Addendum No. 2
Wound Care Relocation
Kings Daughter's Medical Center
Russell, Kentucky

Addendum Issue Date: November 12, 2025

This Addendum is a modification of the Project Manual and Drawings dated September 9, 2025 for the construction of the above listed project. The modifications, revisions, and clarifications are as follows:

Issued by: Zachwieja Workman Architects/Consultants, Inc.

(MEDICAL GAS)
NEW WORK - FLOOR PLAN - PLUMBING

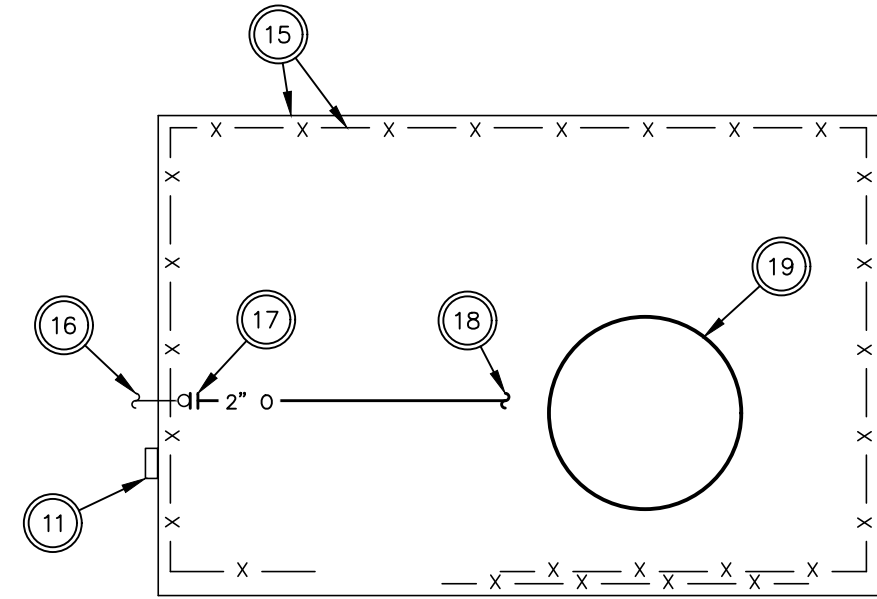
- Item 7: Drawing P2.3:
A. See attached drawing for addition of oxygen piping serving hyperbaric chambers and bulk oxygen storage system.
- Item 8: Drawing P3.1:

- 1/2" 0 PIPING DOWN IN WALL TO MED GAS OUTLET.
- 1/2" 0 PIPING DOWN IN WALL TO MED GAS OUTLET, TO BE INSTALLED UNDER ADD ALTERNATE.
- 1/2" 0 PIPING DOWN IN WALL, EXTEND 1/2" 0 PIPING TO EACH MED GAS OUTLET, TO BE INSTALLED UNDER ADD ALTERNATE.

- SEE "NEW WORK - EXPANDED FLOOR PLAN - PLUMBING" THIS SHEET FOR CONTINUATION.
- SEE "NEW WORK - FLOOR PLAN - PLUMBING" THIS SHEET FOR CONTINUATION.
- EXISTING ELECTRICAL SPLICE BOX. SPLICE AND EXTEND EXISTING CONDUIT AND WIRE TO NEW BULK OXYGEN STORAGE SYSTEM AS REQUIRED.

- LOCKABLE MED GAS SHUTOFF VALVE.
- MEDICAL GAS GRADE REGULATOR, SET FOR 55 PSI.
- EXISTING 0 LINE TO BULK OXYGEN STORAGE PAD, SEE "NEW WORK - SITE PLAN - PLUMBING" THIS SHEET FOR CONTINUATION.

- EXISTING CONCRETE PAD AND FENCED IN ENCLOSURE.
- SEE "NEW WORK - EXPANDED FLOOR PLAN - PLUMBING" THIS SHEET FOR CONTINUATION.
- 2" 0 PIPING. TIE INTO EXISTING 2" 0 PIPING IN VERTICAL.

EMERGENCY OXYGEN SUPPLY CONNECTION
N.T.S.

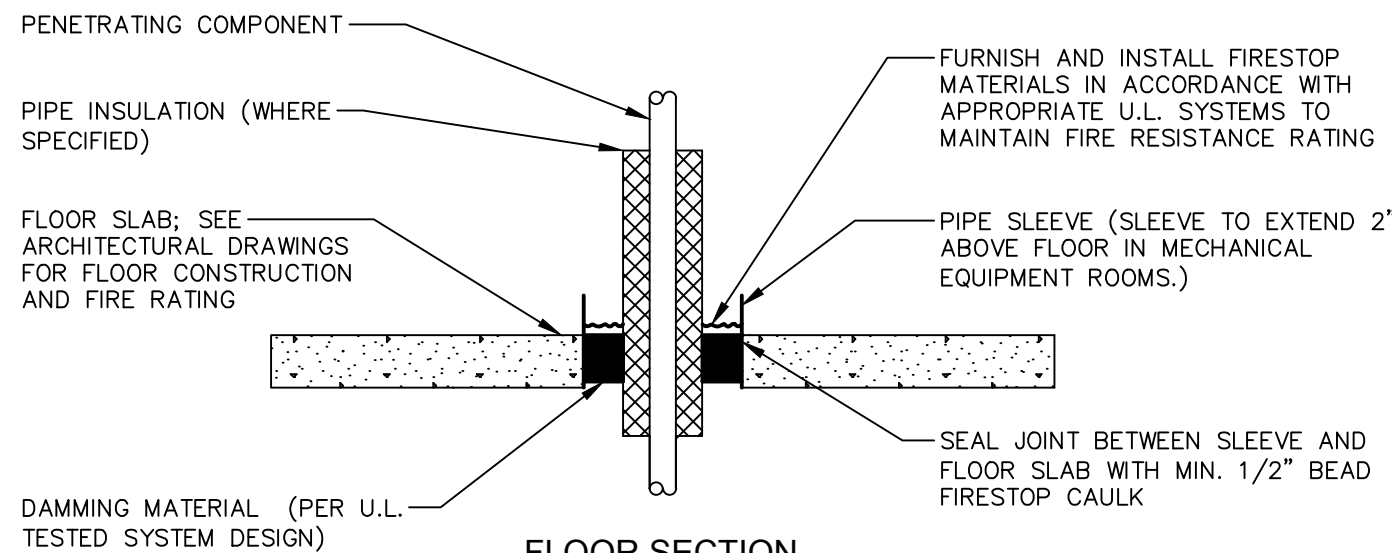
A. See attached drawing for addition of emergency oxygen supply connection detail.
- Item 9: Drawing M2.1:
A. See attached drawing for addition of fire dampers.
